Proposal #20: 1020-00-80, WISC 2025121
Hudson - Baldwin
St. Croix River B-55-0061, B-55-0126
IH 94
St. Croix County

This is Addendum No. 02, which provides for the following:

ADDENDUM NO. 02
PROJECT ID 1020-00-80
March 25, 2025

Addendum No. 02
ID 1020-00-80
Revised Sheet 207
April 1, 2025

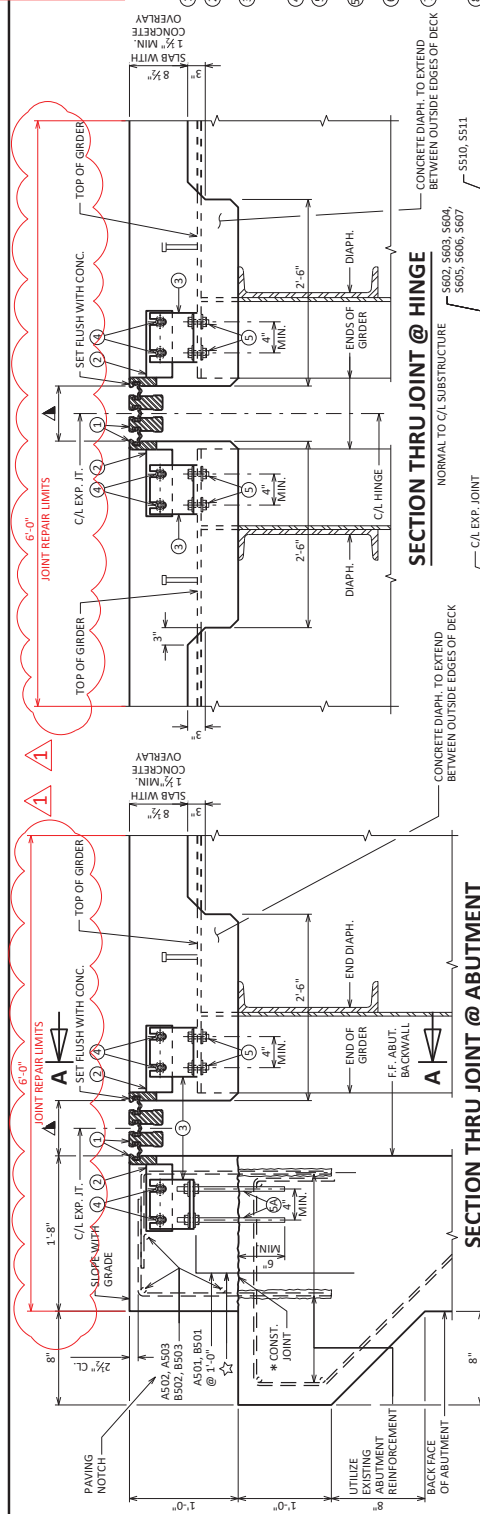
Revised Plan Sheets	
Plan Sheet	Plan Sheet Title (brief description of changes to sheet)
191	Structure B-55-61; General Notes & Quantities – Revised note
207	Structure B-55-126; General Notes and Quantities – Revised note & Revised Quantity table
214	Structure B-55-126; Modular Expansion Joint – Added dimensions
217	Structure B-55-126; Combination Rail Type “C2”
218	Structure B-55-126: Combination Rail Type “C2” Details
220	General Plan R-55-29 (Added additional Temporary Shoring, modified elevations)
221	General Notes, Details,, & Quantities (Added additional Temporary Shoring Quantity, modified MSE wall quantity and added gravity wall quantity. Additional details added for gravity wall)

NO.	DATE	REVISION	BY	AYRES
1	3/31/2025	ADHESIVE ANCHORS		AYRES
2	3/26/2025	REVISED NOTE		AYRES
STATE OF WISCONSIN DEPARTMENT OF TRANSPORTATION				
STRUCTURE B-55-126 MN 82800				
GENERAL NOTES & QUANTITIES				
SHEET 3 OF 15				
207

Addendum No. 02
ID 1020-00-80
Revised Sheet 217
April 1, 2025

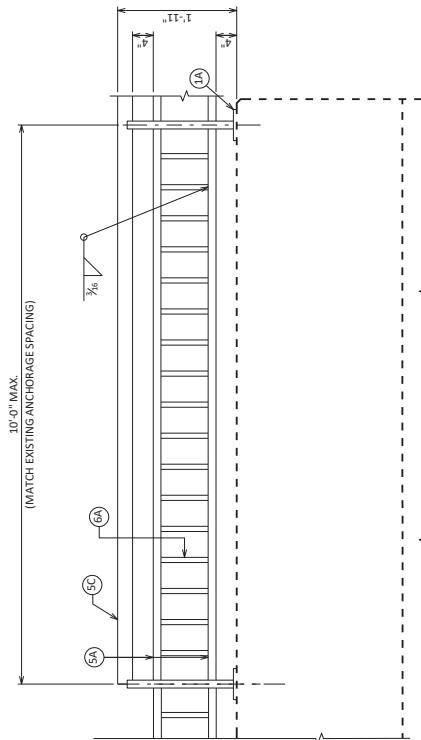
NO.	3/31/2025	ADHESIVE ANCHORS	AYRES
DATE	REVISION	BY	
STATE OF WISCONSIN DEPARTMENT OF TRANSPORTATION STRUCTURES DESIGN SECTION			
STRUCTURE		B-55-126	MN 82800
DESIGNED BY		DRS	CKD
CHECKED BY		DRS	CKD
COMBINATION		RAILINGS TYPE C2	
SHEET 13 OF 15		217

Addendum No. 02
ID 1020-00-80
Revised Sheet 220
April 1, 2025

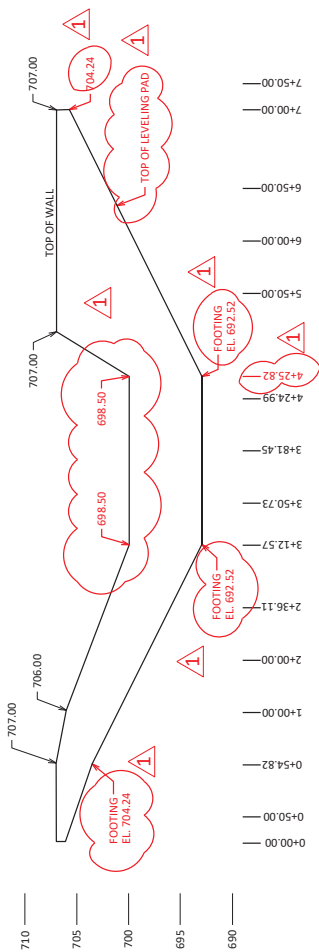
INTERLOCKING BLOCK RETAINING WALL

INTERLOCKING BLOCK RETAINING WALL ELEVATION

Addendum No. 02
ID 1020-00-80
Revised Sheet 221
April 1, 2025

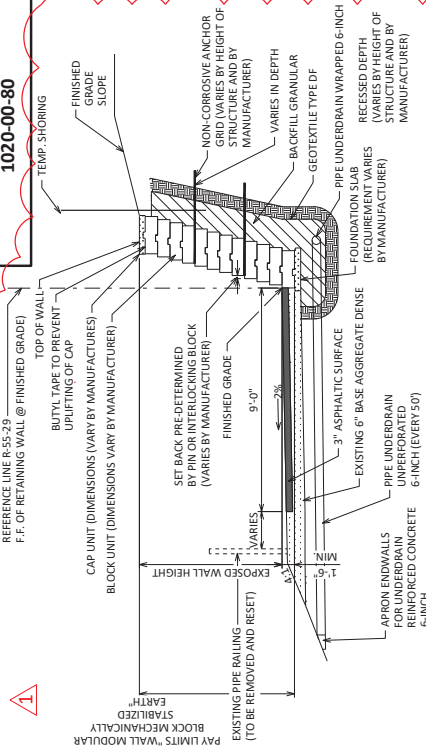
NO.	DATE	REVISION	BY
1	3/31/2025	REVISE WALL TYPE	AYRES
